DATE: July 12, 2022 AGENDA ITEM NO. 4.A.

TO: Historic & Cultural Preservation Committee

SUBJECT: **Amy's Kitchen Corporate Office**
Major Historic Site Plan and Architectural Review (HSPAR)
Address: 109 Kentucky St
APN: 006-363-020
File No: PLSR-2022-0018

Figure 12: Proposed East Façade.

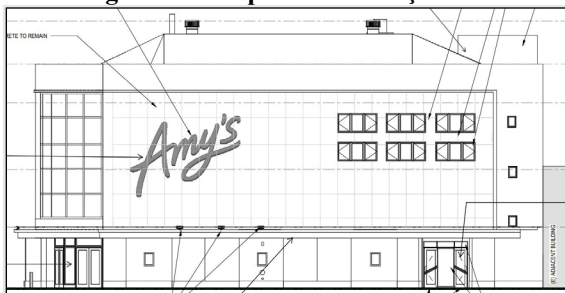
Proposed modifications to the East facade include the alteration of the northernmost historic double door entrance to provide separate access into the fire escape staircase and the main ground floor while retaining the existing door opening. The existing doors’ arrangement with the two

sidelites on either side of the doors would be removed, the historic doors would be reused, and an infill panel would be placed in between the historic doors. The infill wall is a central panel and transom panel to match the canopy and storefront door finish. Curve transition detail at the top of the transom panel would be retained. Exterior lighting fixtures located on the canopy are to be reused. The East elevation also includes the primary *Amy's* wall-mounted sign as mentioned in the previous section. As indicated in the elevation drawing (Figure 12), the East façade contains the enlargement of existing window openings with a change of window type and addition of new windows below the original windows.

The project modifies the northernmost historic double door entrance of the East façade to provide a separate access into the fire escape staircase. Attention to detail and use of existing materials is supported by reusing the existing doors and placing an infill wall in between. The new door framing is proposed to match the finish of the existing door frame and continue the existing curved transition detail at the top of the transom panel. As such, the project is consistent with this guideline.

The project would alter the northernmost historic double door entrance on the East façade to a new double-door with an infill wall to provide separate access into the fire escape staircase and the main ground floor. The infill wall is a central panel and transom panel to match the canopy and storefront door finish. The historic doors are reused with the infill wall in between and its new door framing to match the finish of the existing door frame. Curve transition detail at the top of the transom panel would be retained. Rehabilitating the historic double doors with minor alterations to address and correspond with the interior fire staircase is an appropriate method to the exterior of the building. This continuous the use of the historic entrance doors, matching in material and finish, supporting a cohesive alteration to the existing entryway. As such, the project is consistent with this guideline.

Figure 13: Proposed South Façade.

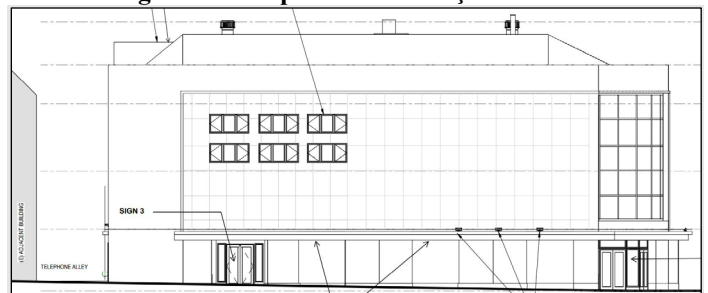
Similar to the proposed East façade, the proposed South façade contains the enlargement of existing window openings with a change of window type and addition of new windows below the original windows. Additional features to the South façade include the new door sign at the southernmost entrance doors. Exterior lighting fixtures located on the canopy are also to be reused.

Figure 14: Proposed West Façade.

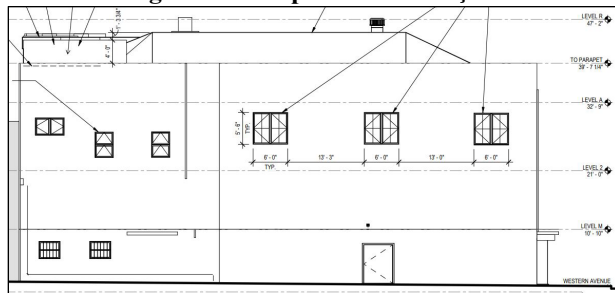
Proposed modifications to the West façade include the enlargement of three existing windows and replacement of existing windows with casement windows with clear glazing. The new window profile and color is proposed to match the historic windows. One smaller window, located to the far left of the West façade and a service door are also replaced within its existing location.
